UNITED STATES PATENT AND TRADEMARK OFFICE

APPLICATION NO.	FILING DATE	FIRST NAMED INVENTOR	ATTORNEY DOCKET NO.	CONFIRMATION NO.
10/560,703	12/13/2005	Takefumi Nishimuta	5000-5290	9339
27123	7590	01/03/2008		
MORGAN & FINNEGAN, L.L.P. 3 WORLD FINANCIAL CENTER NEW YORK, NY 10281-2101			EXAMINER SHINGLETON, MICHAEL B	
			ART UNIT 2815	PAPER NUMBER
			NOTIFICATION DATE 01/03/2008	DELIVERY MODE ELECTRONIC

Office Action Summary

DETAILED ACTION

Figure 4 of Lee.

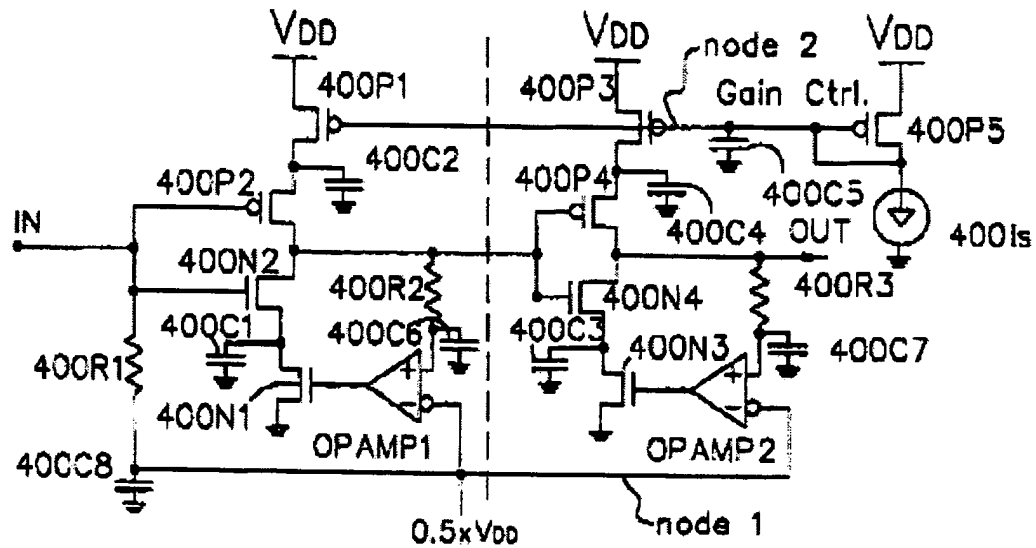
Figure 4 of Lee discloses a low noise amplifier circuit having a CMOS (400P2, 400N2) and a feedback arrangement (OPAMP1, 400N1, 400C1) that is substantially identical to that of applicant's invention (See Figure 11 of applicant's invention.). Lee is silent on the exact construction of the MIS transistors that make up the CMOS arrangement. By being silent, this clearly indicates that any conventional MIS arrangement would work.

Figure 1 of Brunner.

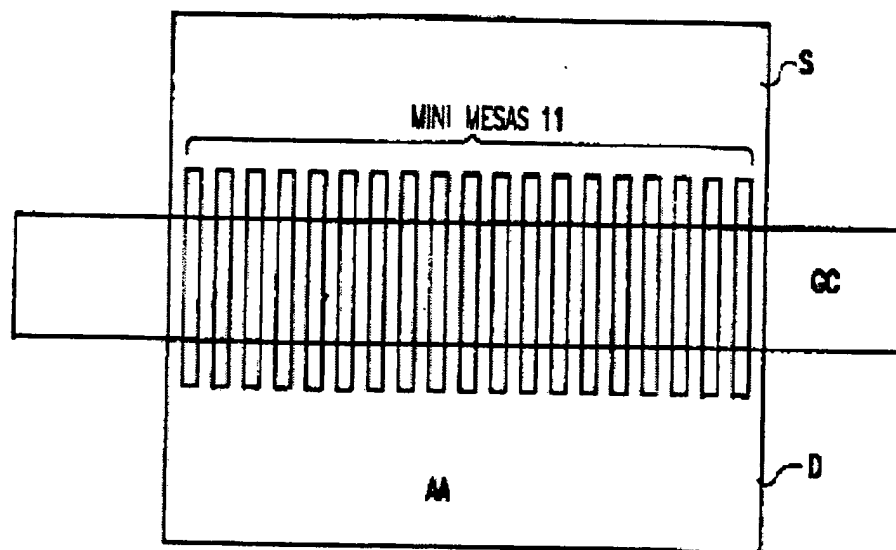
Brunner discloses the specific structure of the MIS transistor as claimed. Of the Figures of Brunner to take note of, Figures 1, 2, 3 and 26 are the most relevant. Applicant should take note that the semiconductor substrate has at least one "fin" that is equivalent to the fin "810A" and "810B" of applicant's invention. Brunner utilizes the term "mesa" for these fins, but the term "fin" is also very common in the art for these transistor arrangements. Brunner is silent on each and every circuit that the transistor can be used in, but the fact is that transistors are meant to be used in circuits, otherwise transistors would not have utility.
